ADDENDUM

PROJECT:	La Vista City Centre South MU – Lot 15	**PROJECT NO.:**	F16132
TO:	Prospective Bidders	**DATE:**	05/04/2017
FROM:	BVH Architecture	**ADDENDUM NO.:**	#2

1 01-GROUND FLOOR - RETAIL - PLUMBING

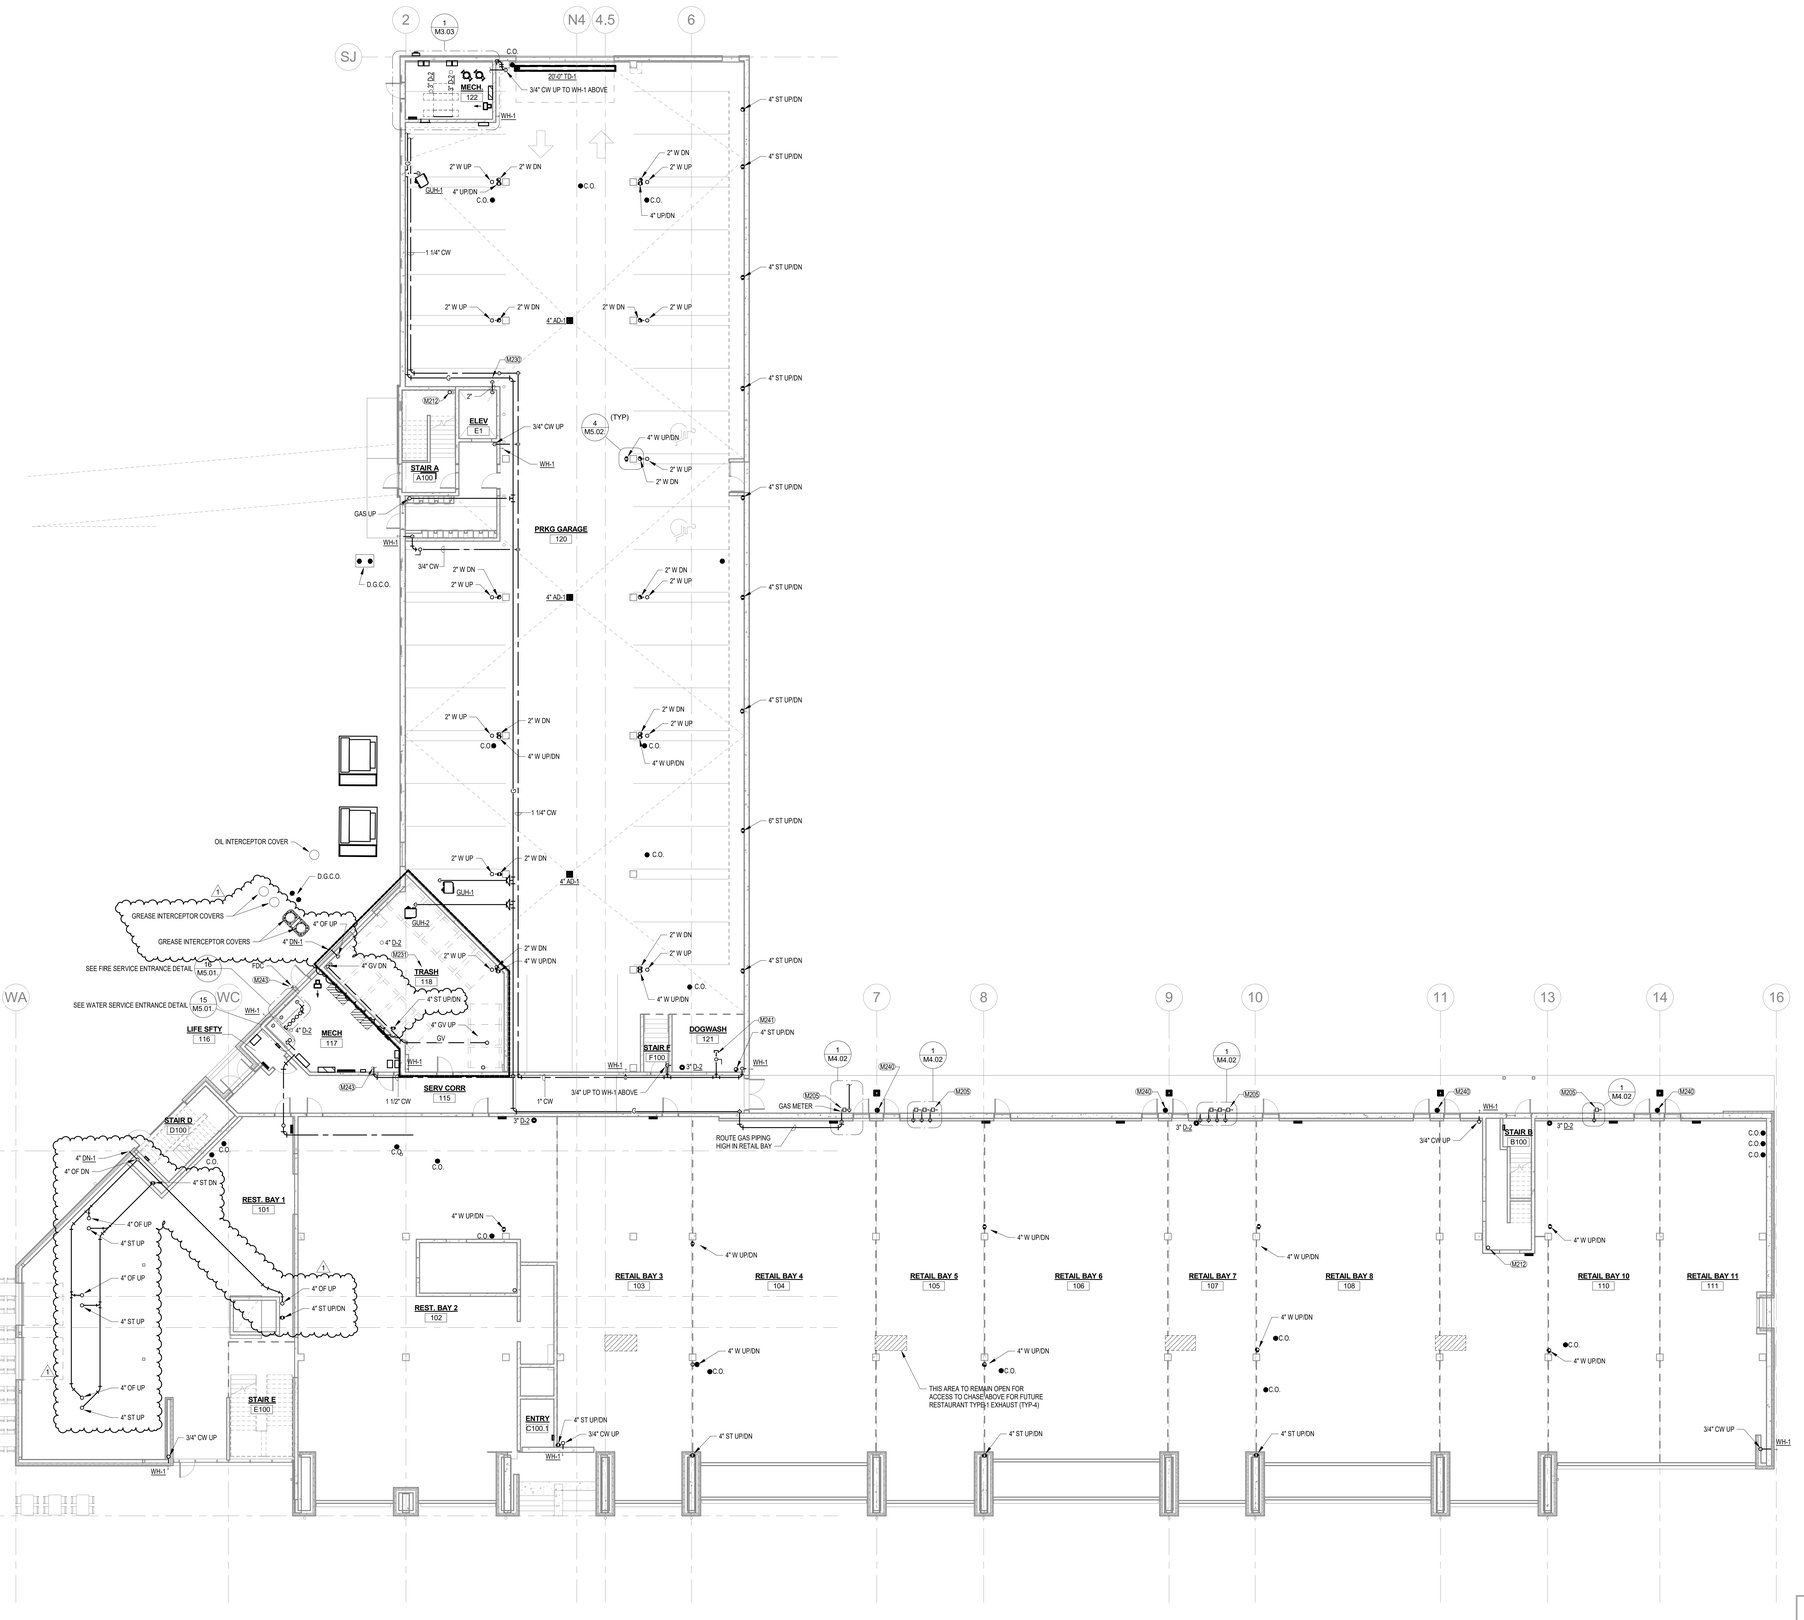
5. Sheet M2.00 – UNDERGROUND PLAN – PLUMBING
    a. See plan revisions.
6. Sheet M2.01 – GROUND FLOOR – Plumbing
    a. See plan revisions.
7. Sheet M2.02 – Second Floor – Plumbing

1 02-SECOND FLOOR - GARAGE DECK - PLUMBING

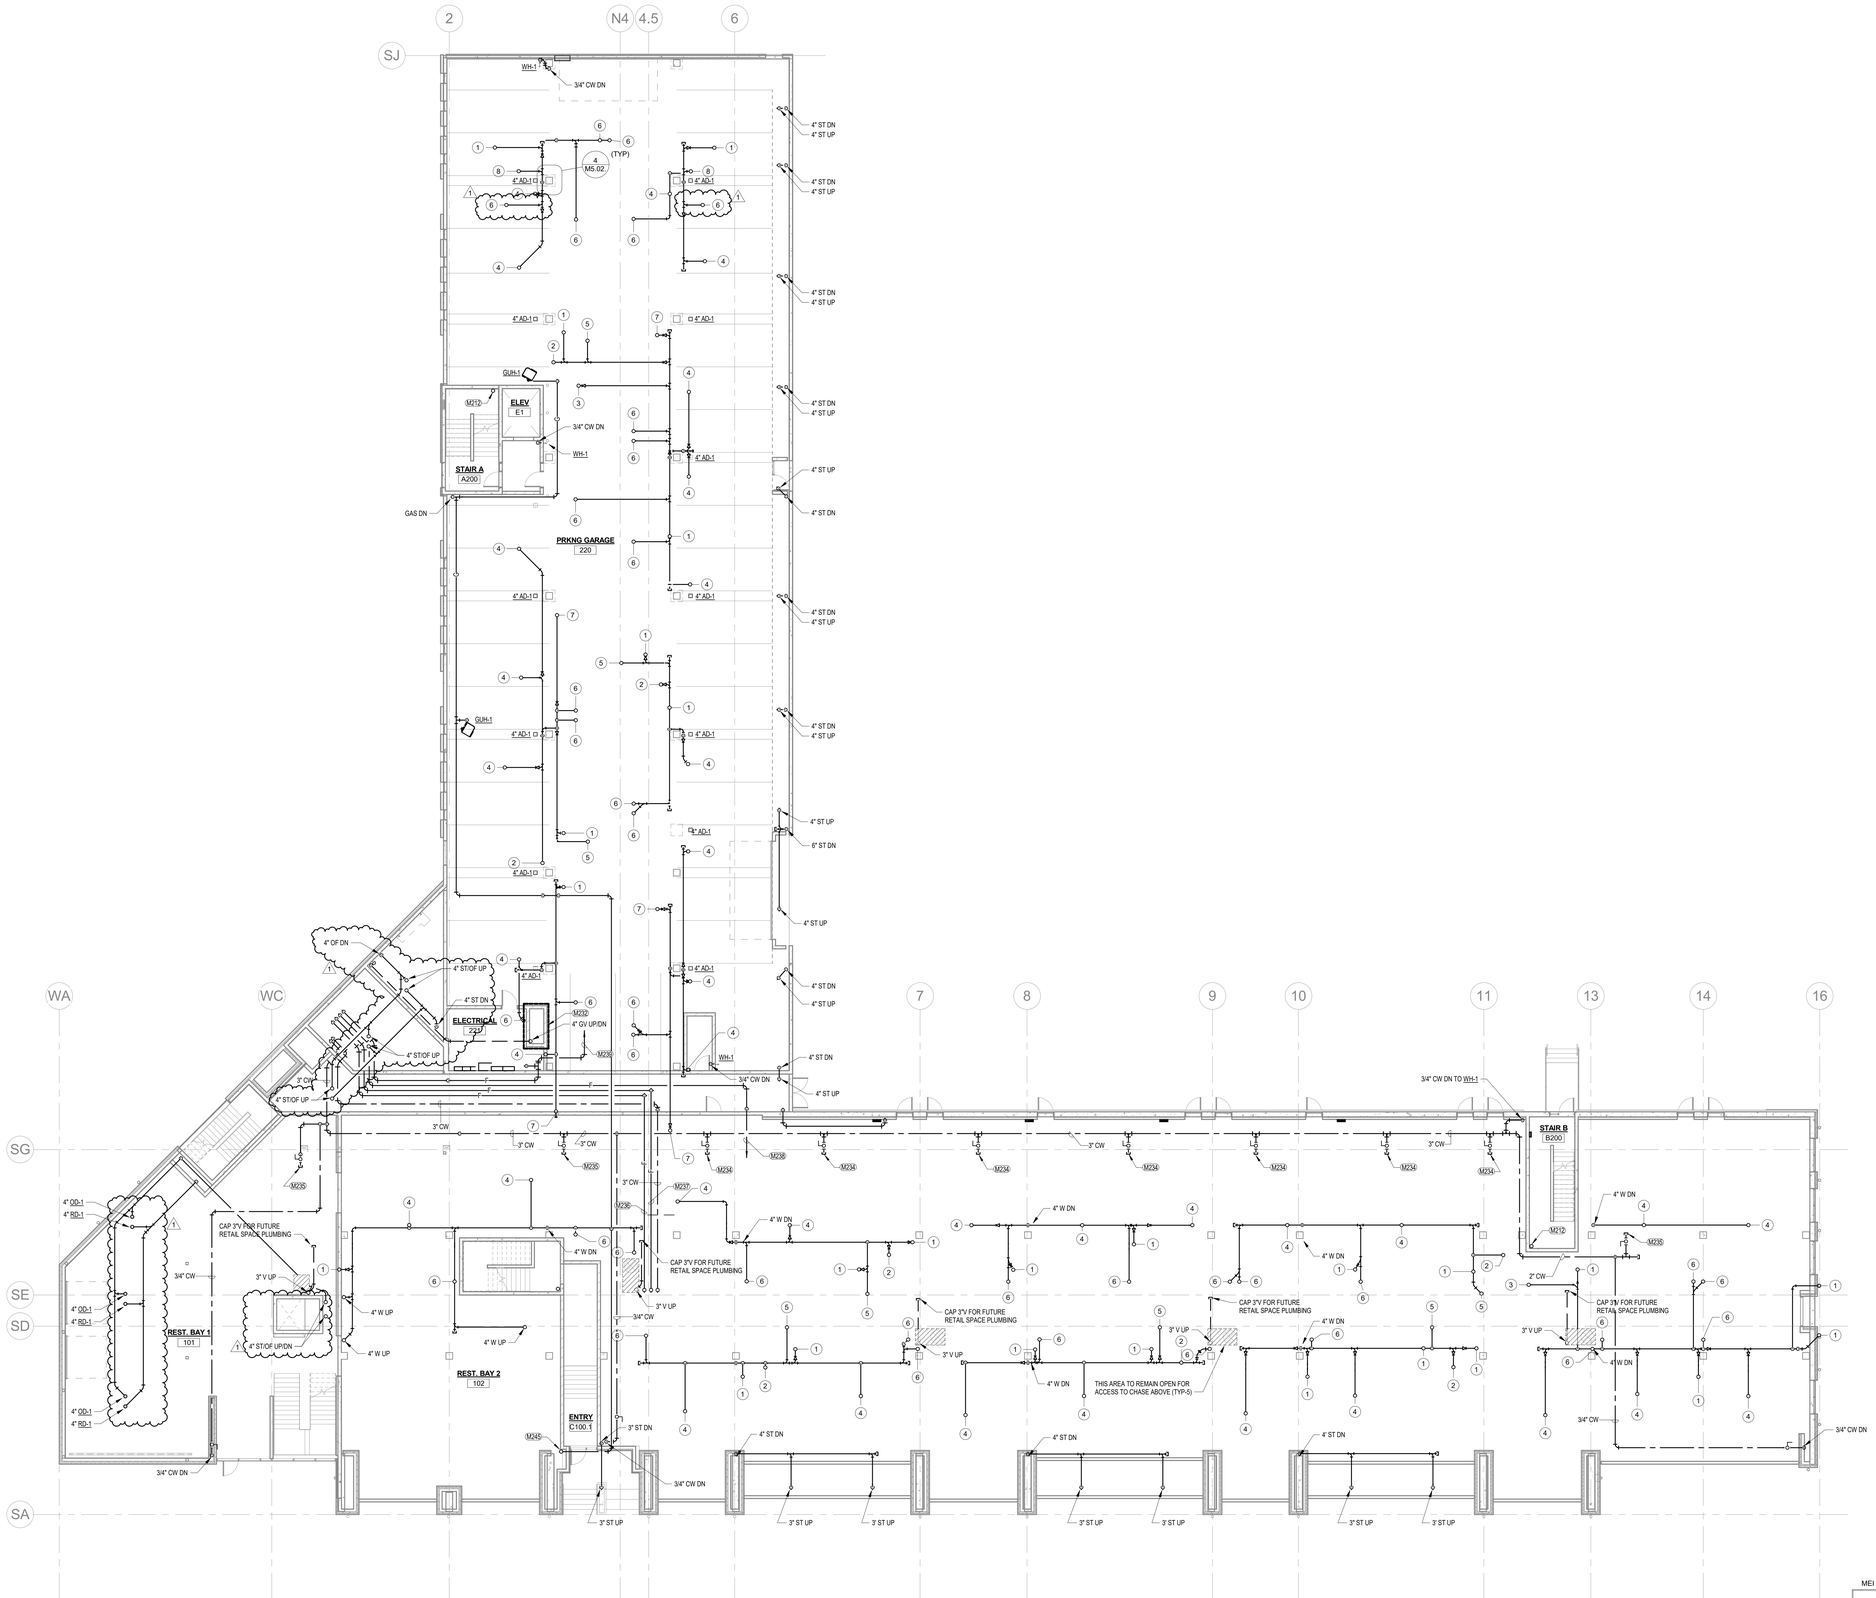
a. See plan revisions
8. Sheet M2.03 – Third Floor – Plumbing
    a. See plan revisions
    b. Room 304 (1 BR – ANSI)
        i. Provide ADA plumbing fixtures in this room, WC-2, BT-2, S-2. See Architectural plans detail 9/A11.1 for ADA fixture locations.

1 THIRD FLOOR THRU SIXTH FLOOR - PLUMBING

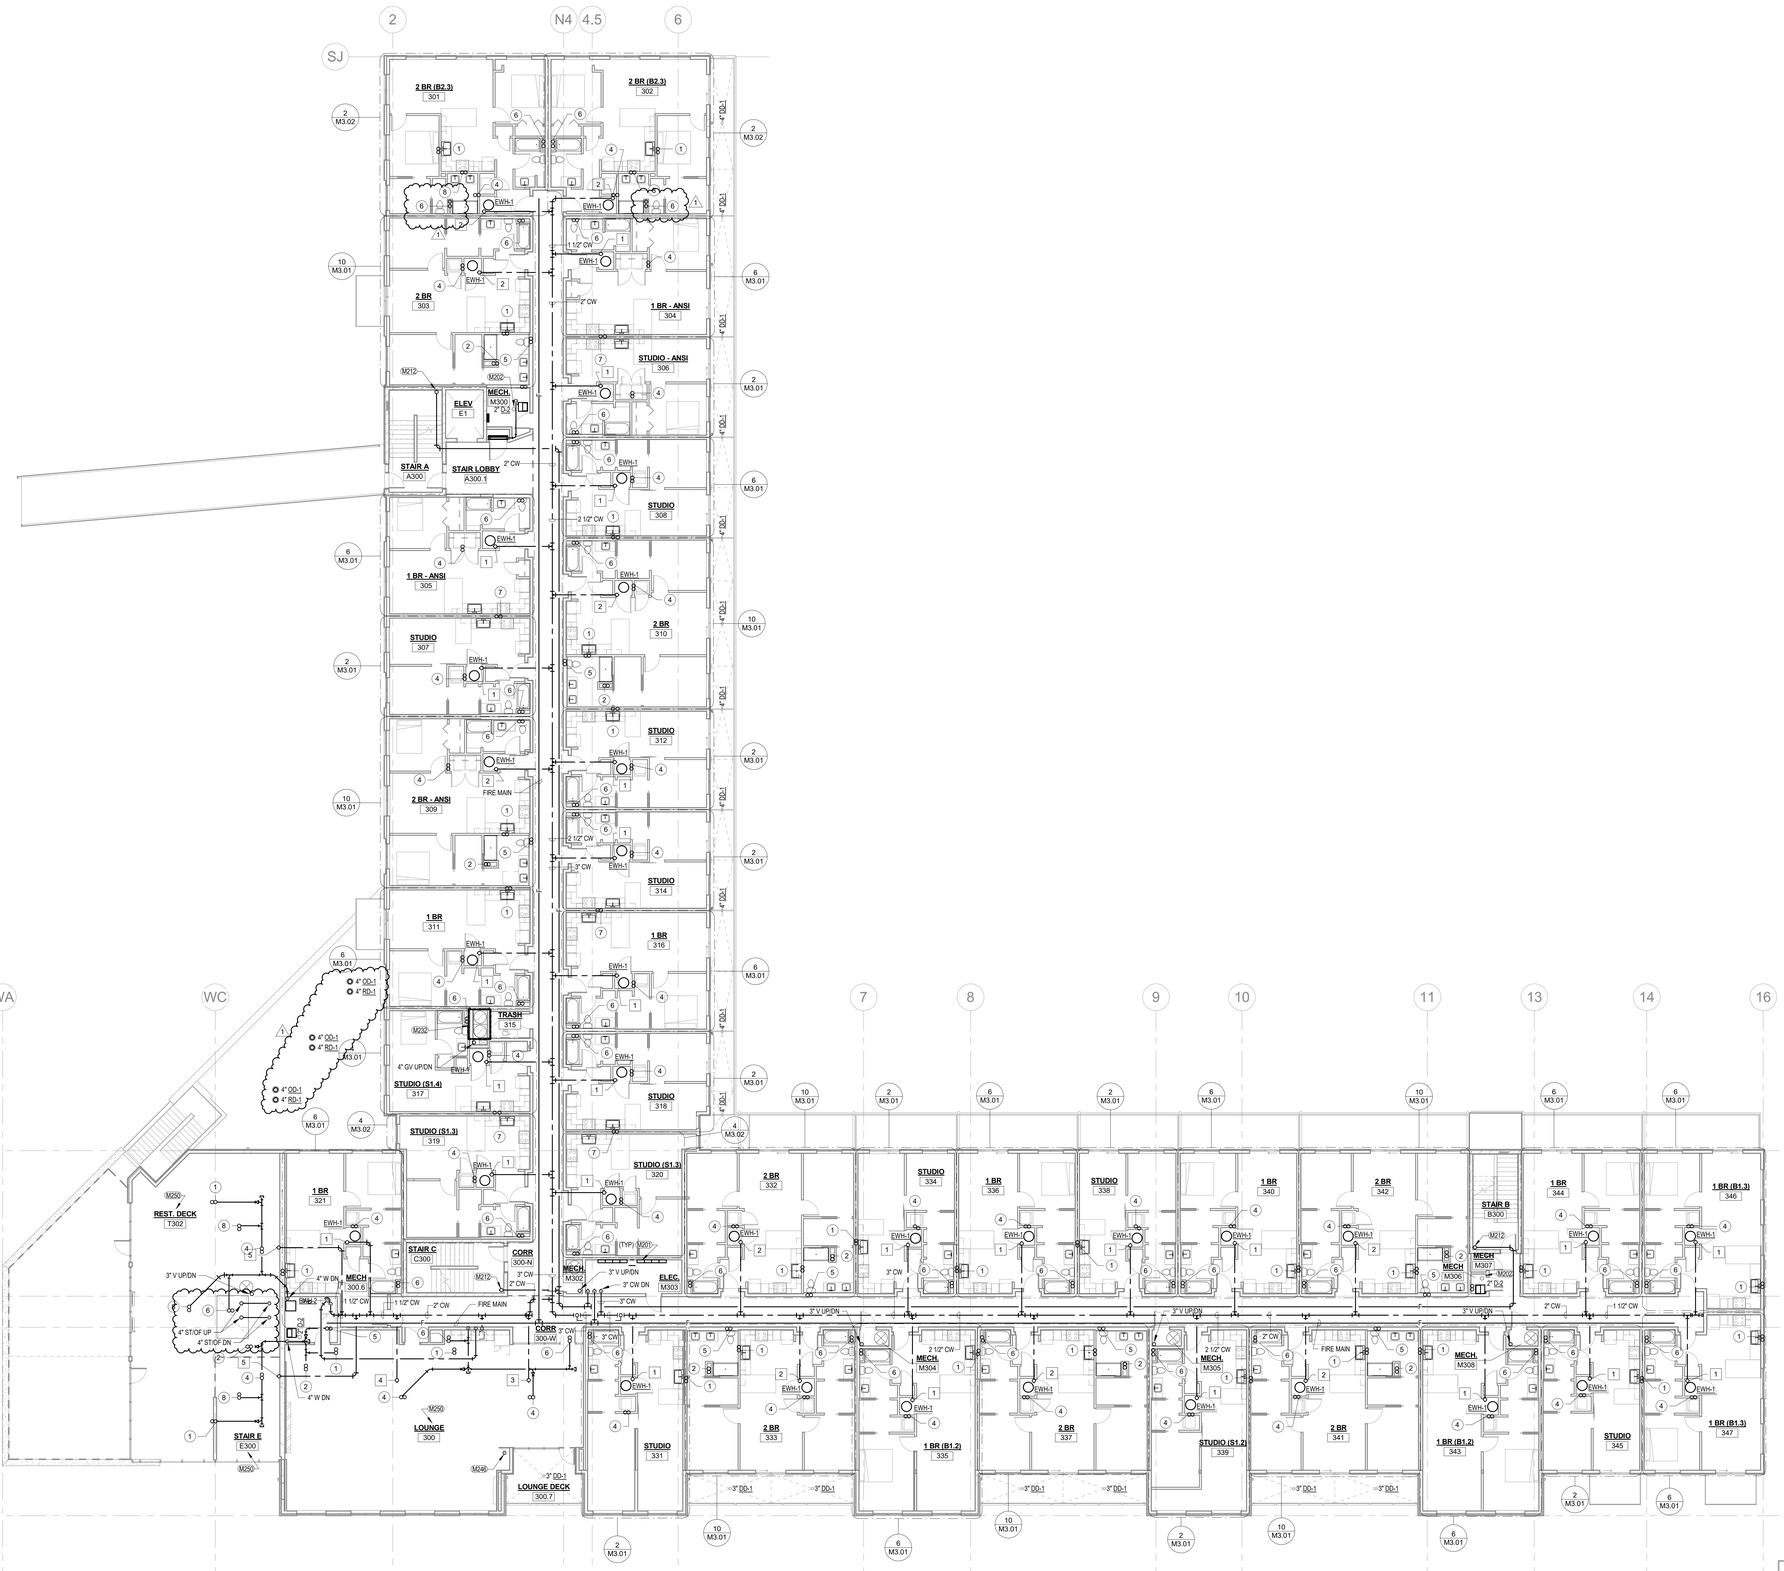
c. Room 305 (1 BR - ANSI)
        i. Provide ADA plumbing fixtures in this room, WC-2, BT-2, S-2. See Architectural plans detail 9/A11.1 for ADA fixture locations.

d. Room 306 (Studio – ANSI)
        i. Provide ADA plumbing fixtures in this room, WC-2, BT-2, S-2. See Architectural plans detail 10/A11.0 for ADA fixture locations.

e. Room 309 (2BR – ANSI)
        i. Provide ADA plumbing fixtures in this room, WC-2, BT-2, S-2. See Architectural plans detail 5/A11.2 for ADA fixture locations.
